General Plan Amendment #24 – 02

Public Hearing General Plan Amendment #24-02, Site Plan Revision #3 to Planned Development #20, Minor Use Permit #24-13, Site Plan #551, Vesting Tentative Subdivision Map #13332 and Environmental Review Checklist #24-25 and Notice of Intent to Adopt a Negative Declaration

RE: General Plan Amendment #24-02 / Site Utilization Plan Revision #3 to Planned Development #20 / Vesting Tentative Subdivision Map #1332 / Site Plan #551/ Minor Use Permit #24-13 – Yosemite Avenue Self Storage and Residential Project

RE: Agenda Item 25-263, PD-20 Zone Change from Commercial Office to Business Park
 and Medium High Density Residential

SHEET TITLE
GRADING PLAN
SCALE: 1" = 40'

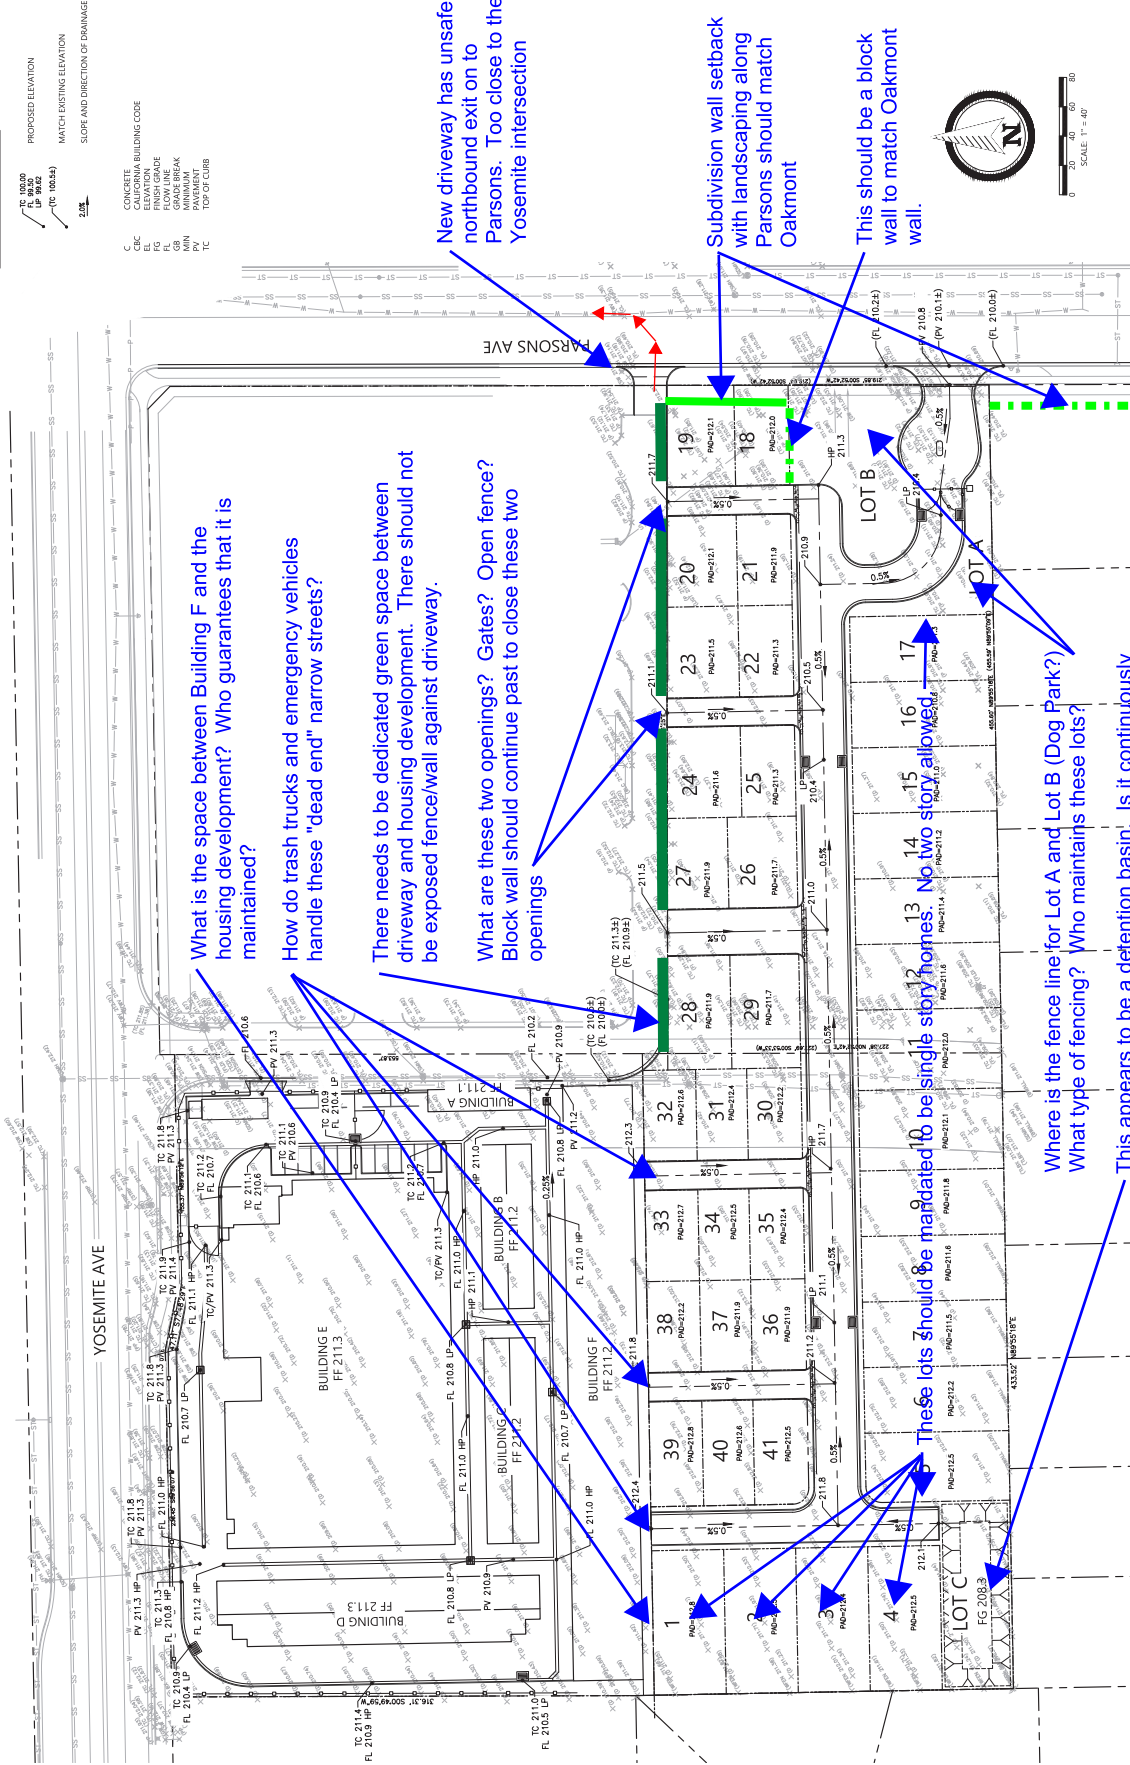
Notwithstanding the misguided principle of placing high density homes against low density, there are many concerns and questions of the 41 lot homesites that have not been addressed. The comments and questions below are shown on the attached Site Plan.

1. Moving the Surgery Center driveway to the north will cause dangerous northbound exits from the Surgery Center (and likely the new mini storage since that driveway will be shared). The existing driveway being used was located where it is to be further away from the Yosemite Avenue intersection for safer traffic movements.

2. Oakmont is currently separated from the Surgery Center by a decorative concrete block wall. The new development should have a matching block wall to separate it from the Surgery Center as well but is not mentioned in the Conditions. Wood fencing deteriorates and is hard to maintain.

3. There is existing greenscape between the current Surgery Center driveway and the Oakmont subdivision wall (redwood trees) which was a likely condition of development of the Surgery Center. There is no greenscape shown on the current plans, which means the driveway will be against the subdivision with a fully exposed wall/fence. With no greenspace, this will foster vandalism and tagging.

4. There is a subdivision block wall between Parsons Avenue and Oakmont. The new development should have a matching block wall at Lots 18 and 19 as well as bordering the new Dog Park. This should be addressed in the Conditions.

5. There is extremely little street parking. Space for street parking is shown only on the “main” street in the development. There is NO space for street parking on the side streets. It appears there is only enough space for 16 cars, which is unrealistic for 42 homes.

7. Developer stated that greenspace would be maintained between the Surgery Center and the housing by having trees inside the housing lots. Placing the responsibility of maintaining trees on to homeowners or tenants is unrealistic. Also the proposed setbacks of 3’-6” does not allow for tree growth.

8. Developer stated that the existing tree line between Oakmont and the Surgery Center would be maintained and even added to towards the west. This is unrealistic in that the trees (if left) would be in the backyards of the new Lots 11-17, which is making the assumption that the new homeowners/tenants will maintain or even want those trees in their yards.

9. City and Developer stated that the Fire Department has reviewed this. How can other subdivisions be required to have a certain radius “end bulb” at dead end streets for required turnaround of emergency vehicles? How will refuse trucks pick up trash in narrow, dead-end streets? Will the streets be required to have a heavy vehicle pavement section? (Thickened pavement to withstand fire and refuse trucks).
